**Observations on Existing Right-of-Way (ROW) Transmission Vegetation Management Program Practices by Electric Utilities and NYS PSC Regulation**

**Submission by Mark Gilliland – GEF LORAX Working Group, chairperson**

FERC Technical Conference on Vegetation Management, Oct. 26, 2010

**Tree heights conforming to distance requirement to avoid arcing for 242 kV lines.**

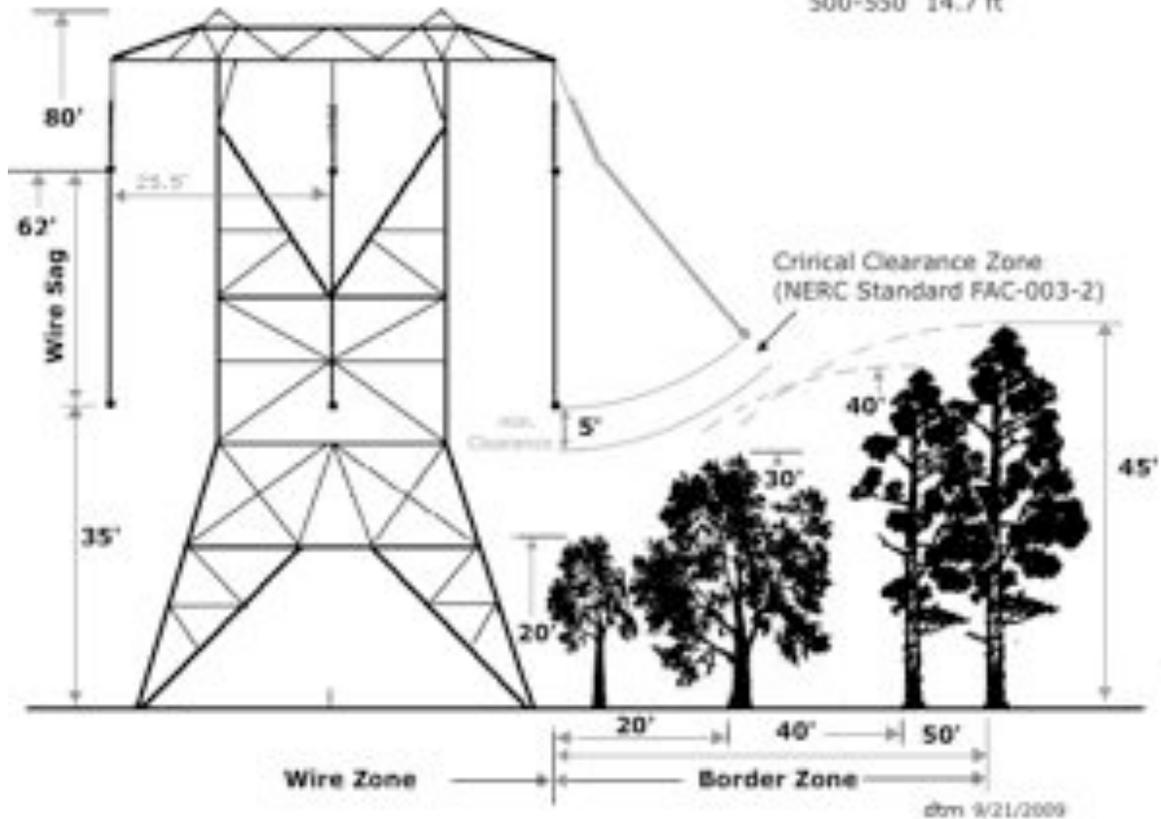
R17: Remove the “Priority Zone” loophole in state guidelines through stricter definition of the term. See diagram (below) for example of a tiered management approach which meets Federal regulations.

R18: Adjust ROW evaluation and VM plans to site-specific, local conditions as described in the “Modified WZ-BZ” approach. Prohibit unconstrained clear-cutting across the ROW in all circumstances.
